# Access Compliance Report

## Public Rights-of-Way

### (Pedestrian Signals)

Intersection ID: N/A	Main Street:	Cross Street: N/A	Location: N/A
ADA ID: 61DF70AC0F3E	Signal Type: One Push Button-Non APS	Overall Compliance: No	Severity Score: BTN 1: N/A BTN 2: N/A No BTN: N/A
Codes/Mitigation Info/Possible Solution		Field Measurements/Component Compliance

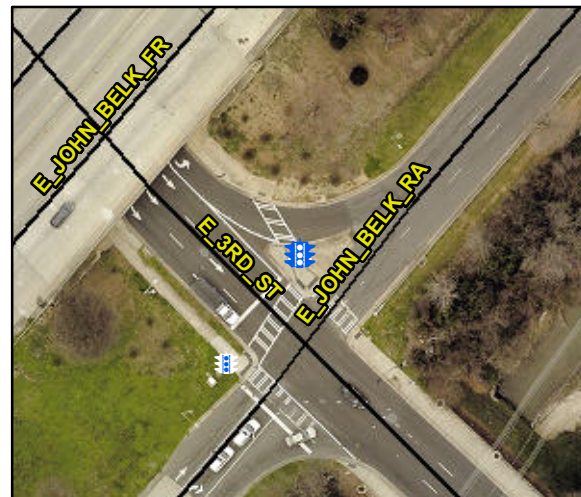
PROW/ADA: R209.1, TMUTCD 4e.08, R404.7.3, R406

Possible Solutions: Replace Signal Push Button With APS Button on New Post. Remove & Relocate Sign.
